SUBJECT: REVISED MAXIMUM AUTHORIZED THERMAL POWER LIMIT, LIMERICK
GENERATING STATION, UNIT NO. 1 (TAC NO. M88392)

The Commission has issued the enclosed Amendment No. 106 to Facility Operating License No. NPF-39 for the Limerick Generating Station, Unit 1. This amendment consists of changes to the Facility Operating License and Technical Specifications in response to your application dated December 9, 1993, as supplemented in letters of July 5, September 9, October 19, November 15, and December 2, 1994, January 6, and January 23, 1995.

This amendment raises the authorized maximum power level from 3293 MWt to a new limit of 3458 MWt. The amendment also approves changes to the Technical Specifications to implement uprated power operation.

Figure 3.4.1.1-1 THERMAL POWER VERSUS CORE FLOW

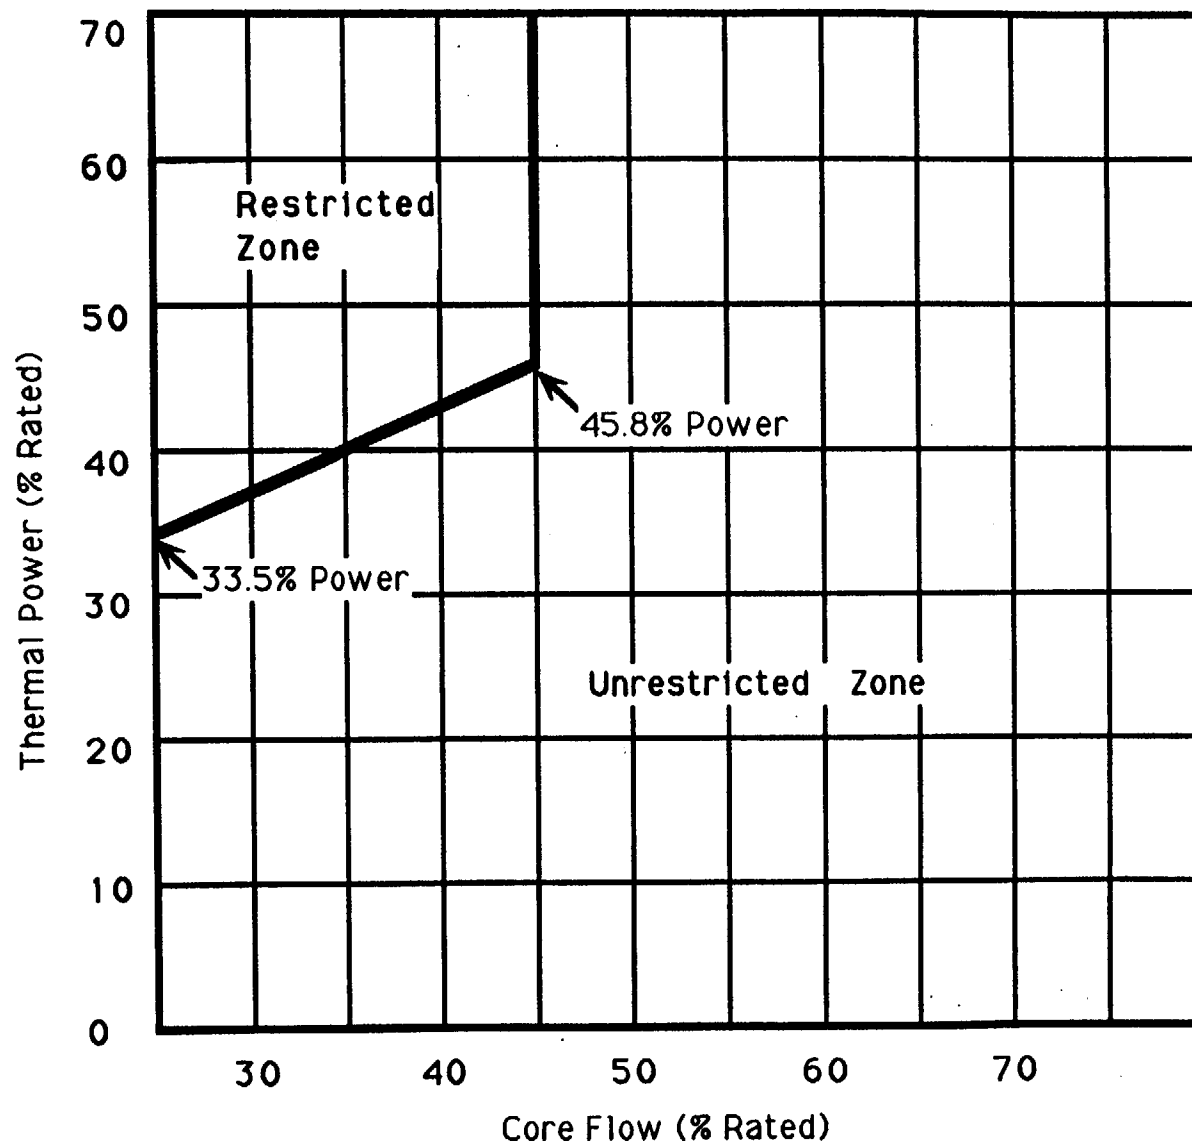
- a. Total core flow greater than or equal to 45% of rated core flow, or
- b. THERMAL POWER within the unrestricted zone of Figure 3.4.1.1-1.

- a. Reactor THERMAL POWER is $\leq 76.2\%$ of RATED THERMAL POWER,
- b. The recirculation flow control system is in the Local Manual mode, and
- c. The speed of the operating recirculation pump is $\leq 90\%$ of rated pump speed.
- d. Core flow is greater than 39% when THERMAL POWER is within the restricted zone of Figure 3.4.1.1-1.

MINIMUM REACTOR VESSEL METAL TEMPERATURE VS. REACTOR VESSEL PRESSURE
FIGURE 3.4.6.1-1

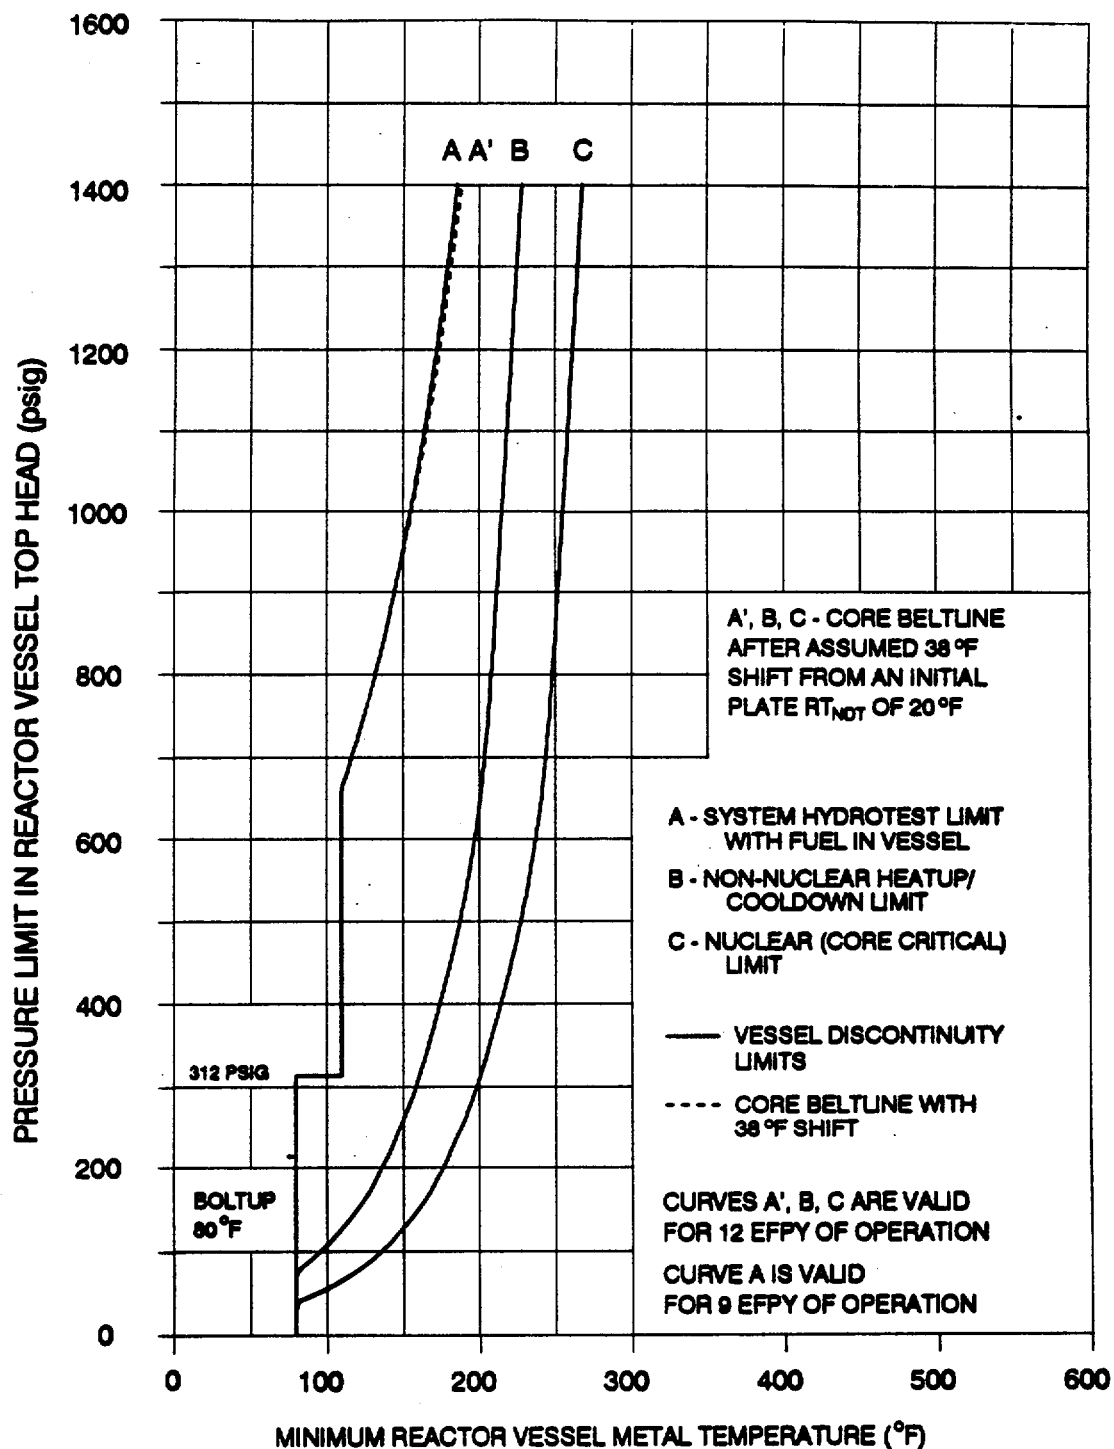
4.4.6.1.1 During system heatup, cooldown and inservice leak and hydrostatic testing operations, the reactor coolant system temperature and pressure shall be determined to be within the above required heatup and cooldown limits and to the right of the limit lines of Figure 3.4.6.1-1 curve A and A', B, or C as applicable, at least once per 30 minutes.

The operating limit curves of Figure 3.4.6.1-1 are derived from the fracture toughness requirements of 10 CFR 50 Appendix G and ASME Code Section III, Appendix G. The curves are based on the RT_{NDT} and stress intensity factor information for the reactor vessel components. Fracture toughness limits and the basis for compliance are more fully discussed in FSAR Chapter 5, Paragraph 5.3.1.5, "Fracture Toughness."
